Model: OR-C2		Date: 20-Sep-13	No.: RD184001
Subject: Data Overwrite Security Unit Type I		Prepared by: T. Nihei	
From: 2nd Tech Service Sect., MFP/P Tech Service Dept.			
Classification:	<input type="checkbox"/> Troubleshooting	<input type="checkbox"/> Part information	<input type="checkbox"/> Action required
	<input type="checkbox"/> Mechanical	<input type="checkbox"/> Electrical	<input checked="" type="checkbox"/> Service manual revision
	<input type="checkbox"/> Paper path	<input type="checkbox"/> Transmit/receive	<input type="checkbox"/> Retrofit information
	<input type="checkbox"/> Product Safety	<input type="checkbox"/> Other ()	<input type="checkbox"/> Tier 2

Service Manual Revision

Please revise the following in the Service Manual.

Data Overwrite Security Unit Type I (D362)

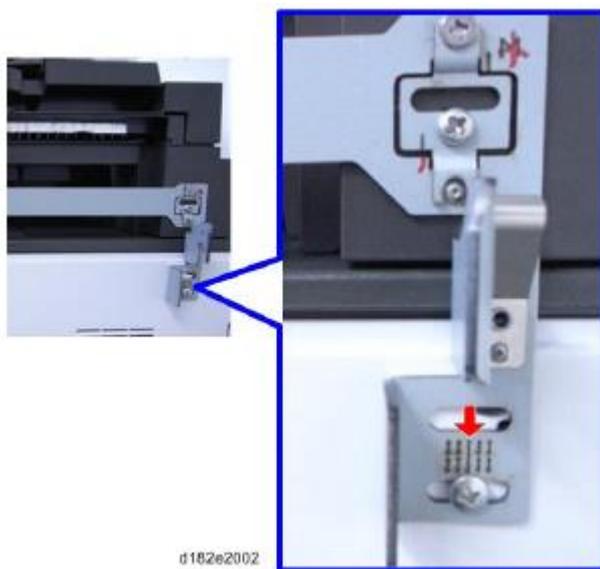
Make sure to tighten the screw in the center position of the opening, as shown below.

16.Transfer/Separation Section (D182/D183/D184)

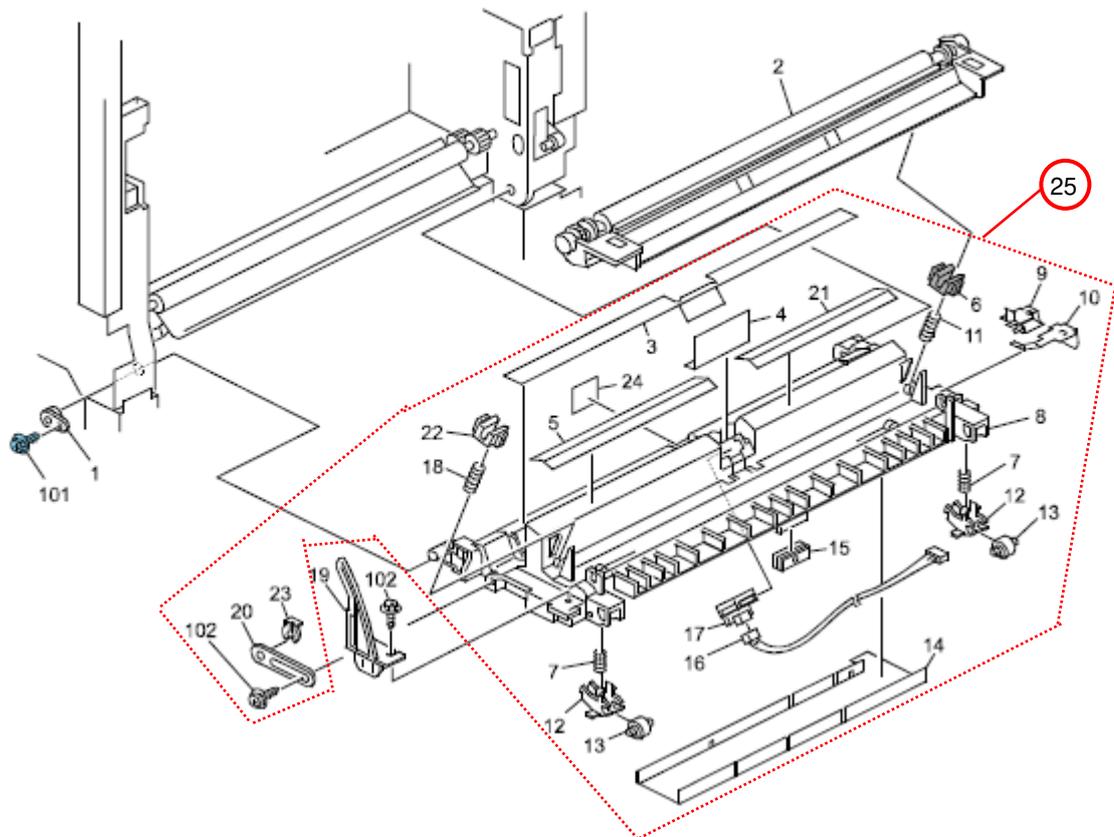
Change: The parts boxed in red in the illustration were registered as an assembly.

Reason: To meet requests from the field.

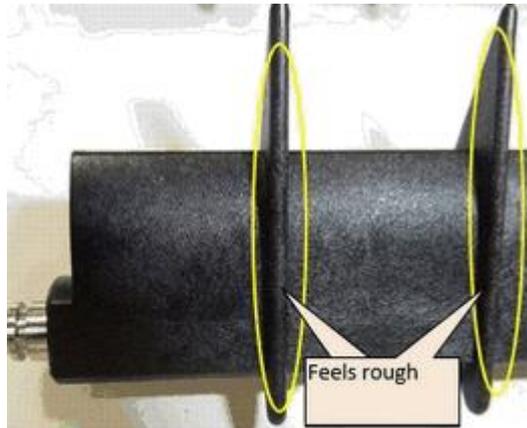
CAUSE

The paper catches on the rough surface of the lower gate pawl (P/N AF025045).

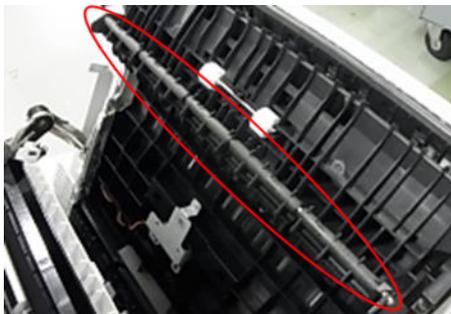
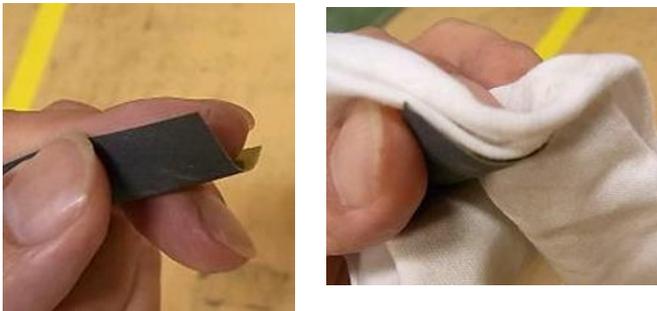
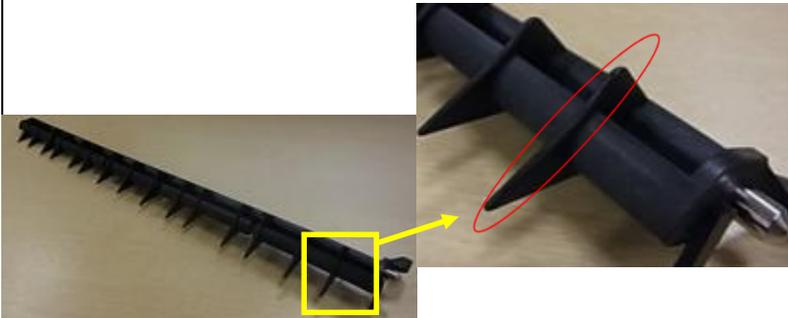
In the field

Do the following procedure.

Part	Instructions
1	<p>GATE PAWL:LOWER (AF025045)</p> 	<p>-Open the machine's right cover. -Remove the lower gate pawl (AF025045).</p>
2	<p>Sandpaper</p> 	<p>-Bend the sandpaper and hold it as shown in the photo on the left.</p> <p>Note: You can also use a cloth between the sandpaper and your finger, as shown in the photo on the right.</p>
3	<p>GATE PAWL:LOWER (AF025045)</p> 	<p>Touch both tips of the gate pawl and check for any sharp or rough edges.</p>

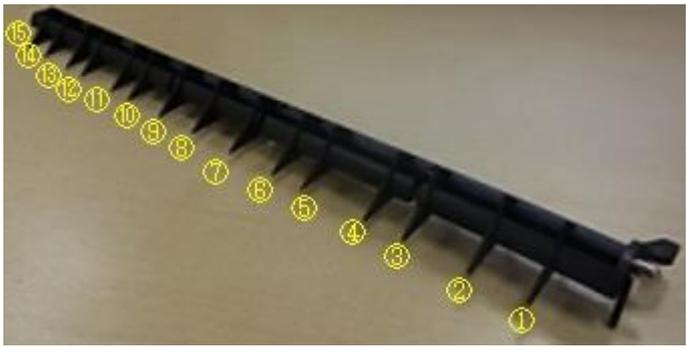
-Use a file to smooth down the edges (marked with numbers in the photo) of each of the 15 pawls.

33.Electrical Section 5 (D182/D183/D184)

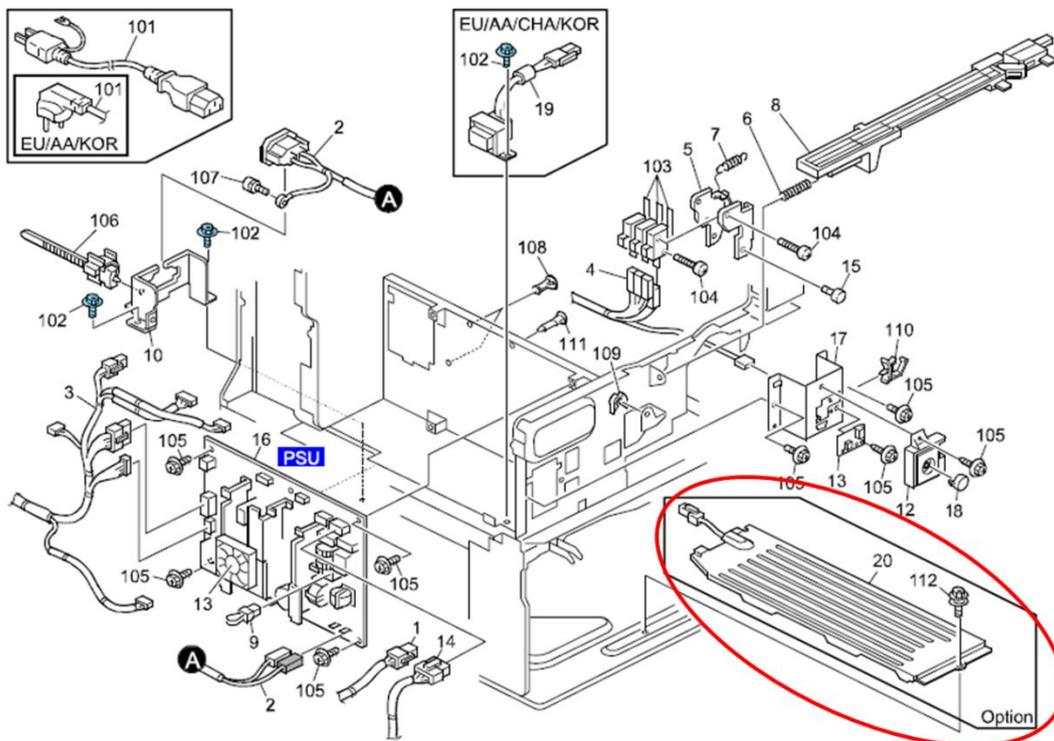
Incorrect part number	Correct part number	Description	Q'ty	Int	Page	Index	Note
D1820076	D1202702	HEATER:NICHROME WIRE:120V:9W:NA	1	X/X	67	20	
D1820077	D1202705	HEATER:NICHROME WIRE:230V:9W	1	X/X	67	20

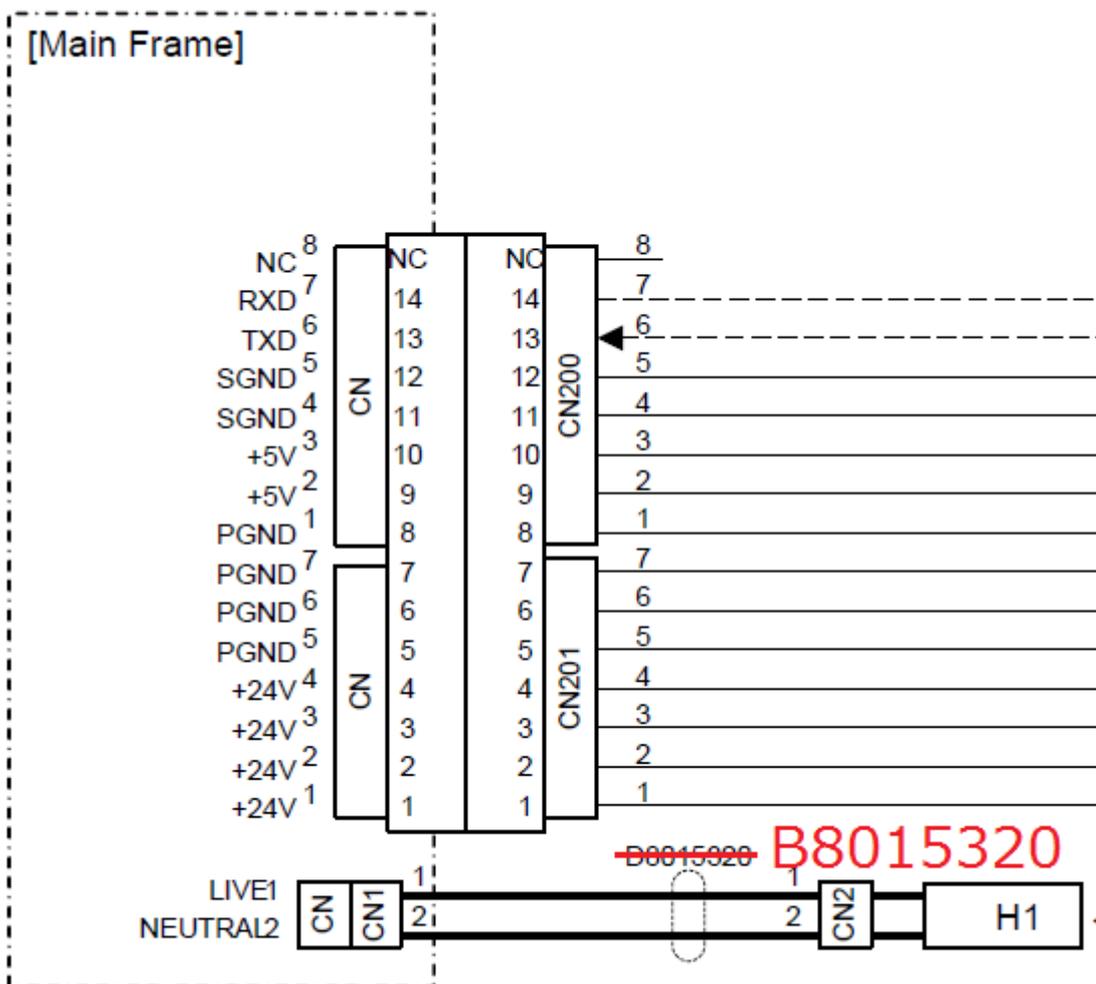
Incorrect P/N	Correct P/N	Name	Page
D8015320	B8015320	HARNESS - HEATER	11/14

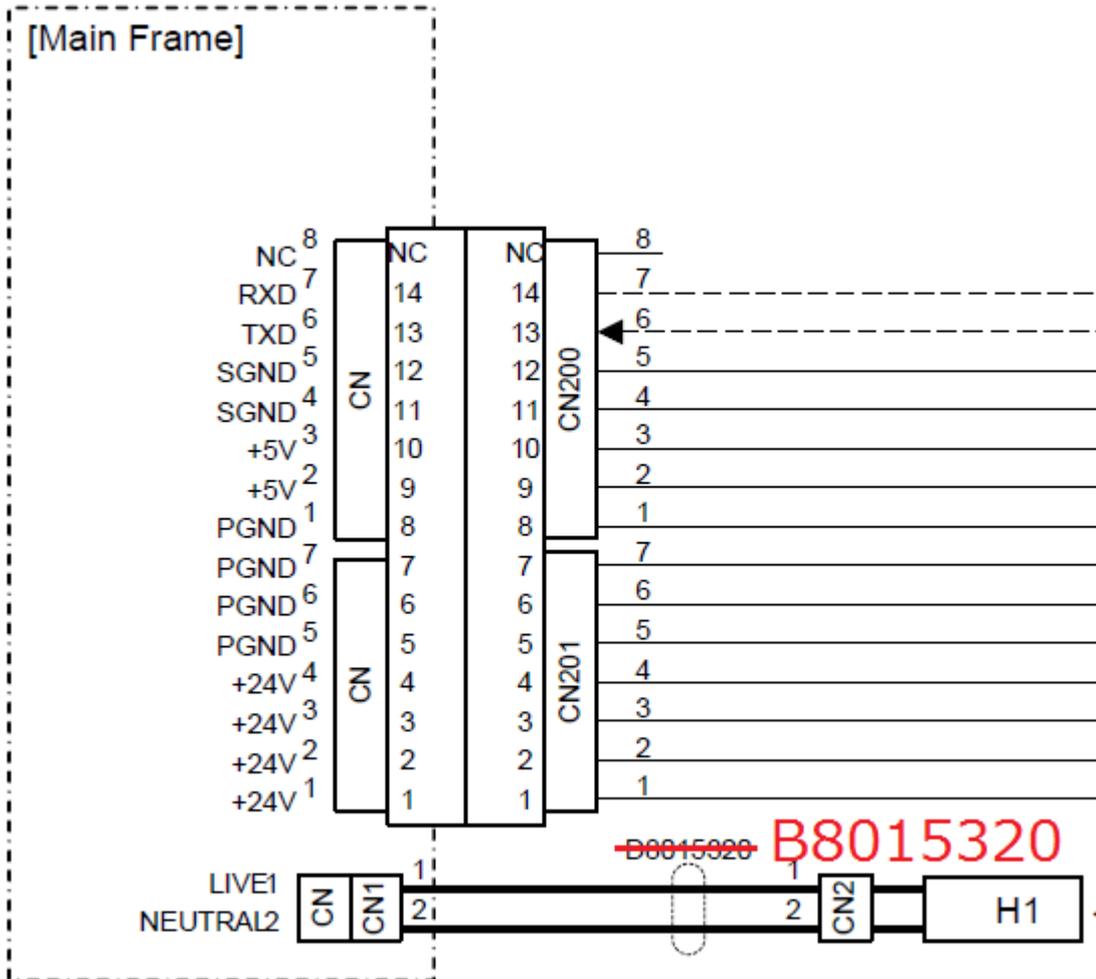
Incorrect P/N	Correct P/N	Name	Page
D8015320	B8015320	HARNESS - HEATER	13/14

25.Duplex Section 5 (D182/D183/D184)

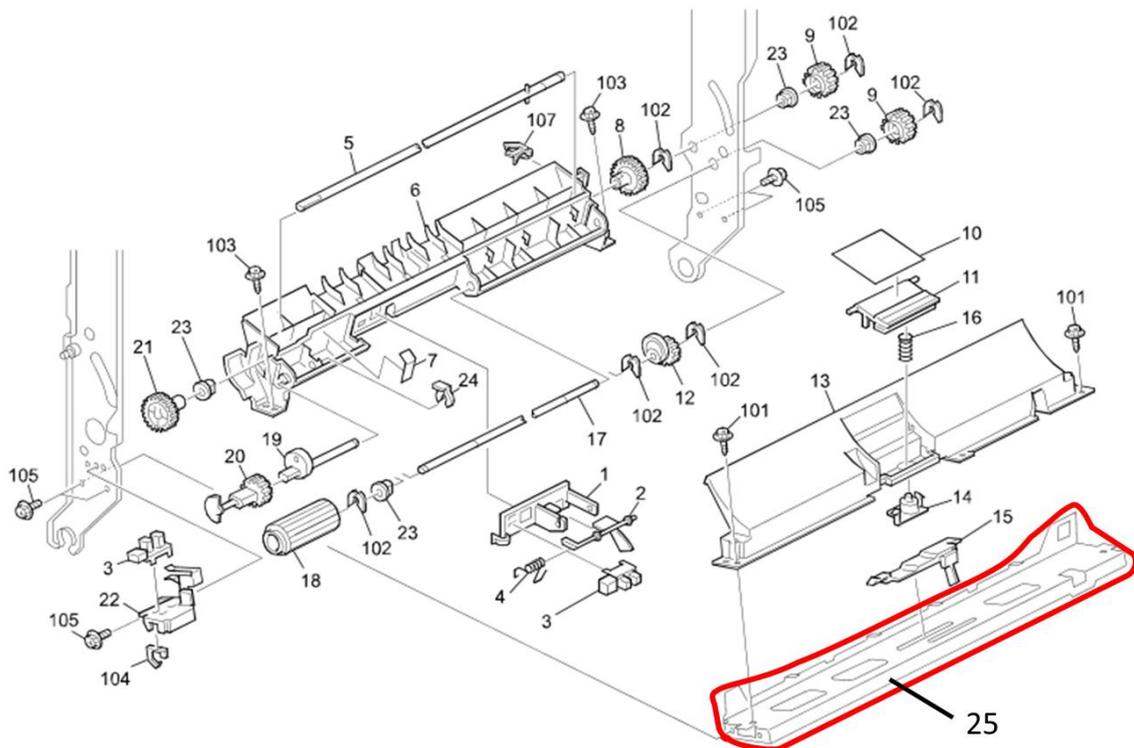
Reason: To meet requests from the field.

1. FAX Option (D759)

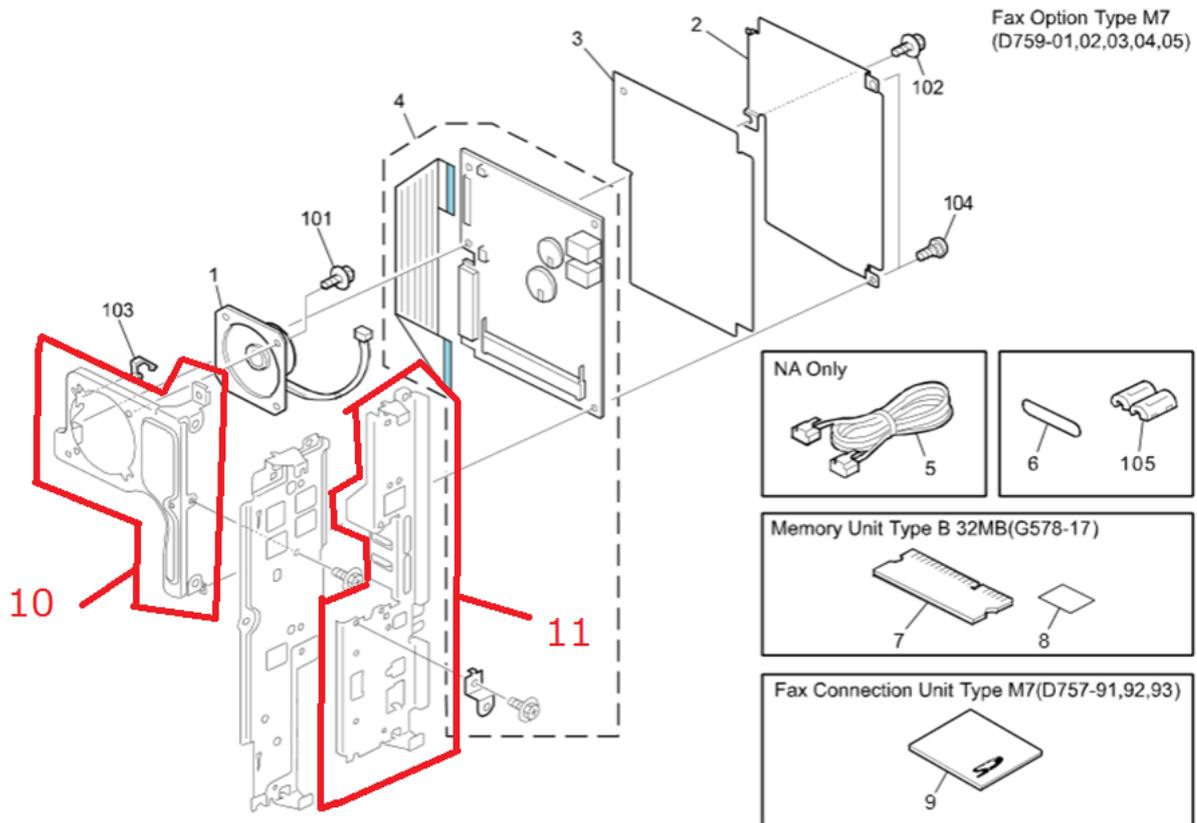
Old part number	New part number	Description	Q'ty	Int	Page	Index	Note
	D1825731	PANEL:FCU:PEEN	0-1	-	3	10	
	D1825868	PANEL:CTL:PEEN	0-1	-	3	11

26.Drive Section 1 (D182/D183/D184)

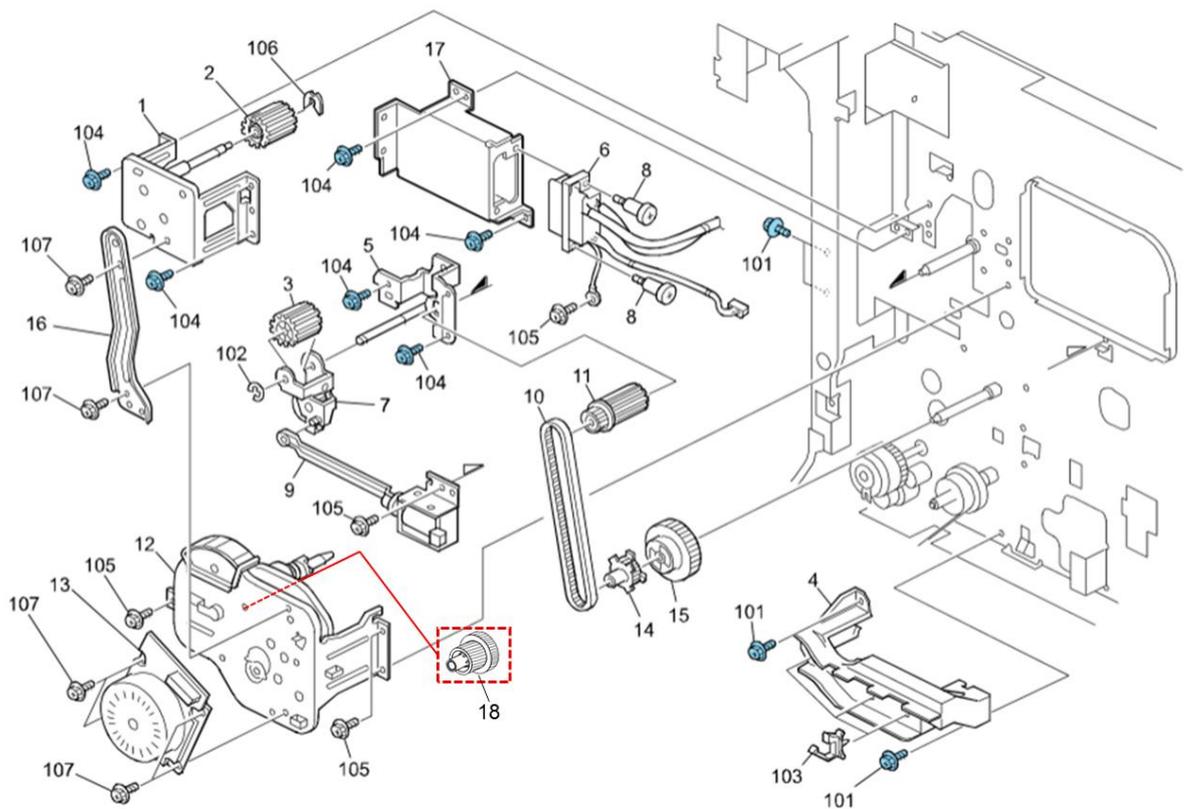
Reason: To meet requests from the field.

17.Fusing Section 1 (D182/D183/D184)

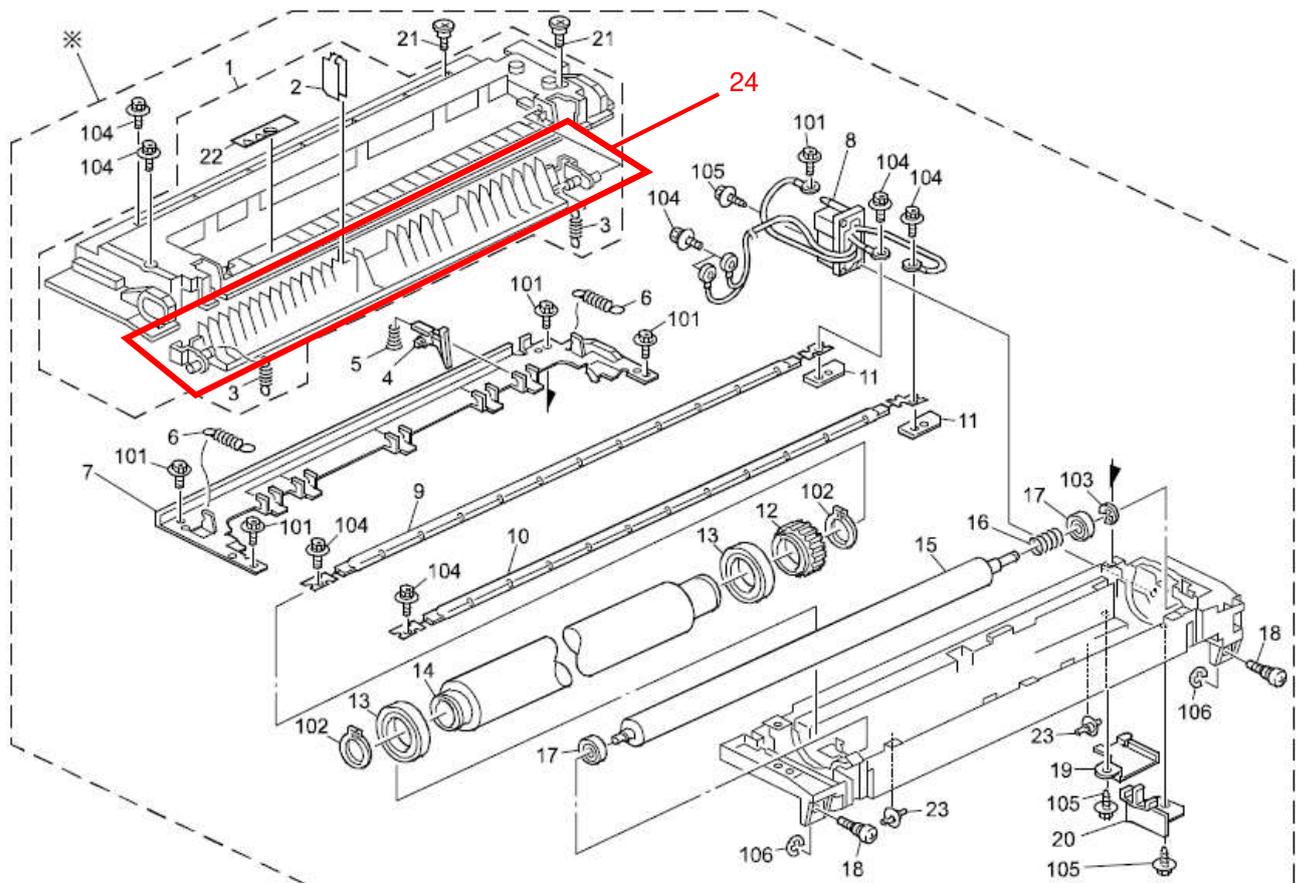
Reason: To meet requests from the field.

21.Duplex Section 1 (D182/D183/D184)

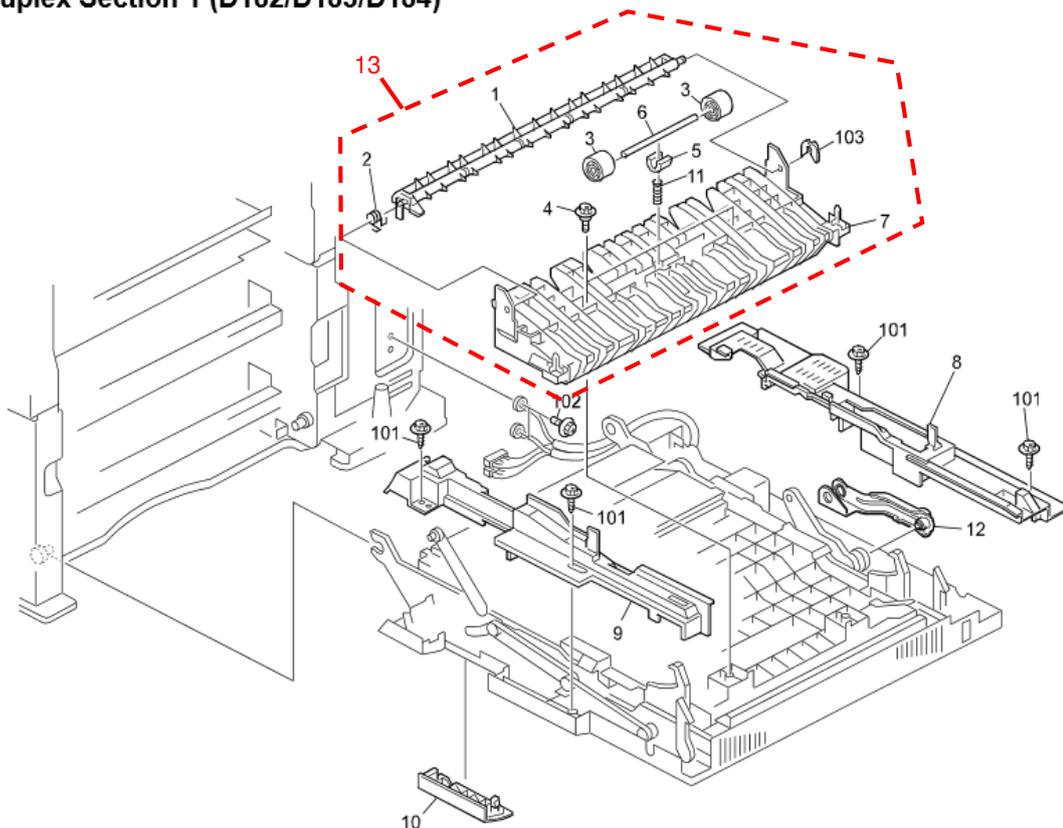
Old part number	New part number	Description	Q'ty	Int	Page	Index	Note
-	D1204673	ARM:STOPPER:PEEN	1	-	43	12	-
-	D1204674	GUIDE PLATE:GATE:ASS'Y	1	-	43	13	-
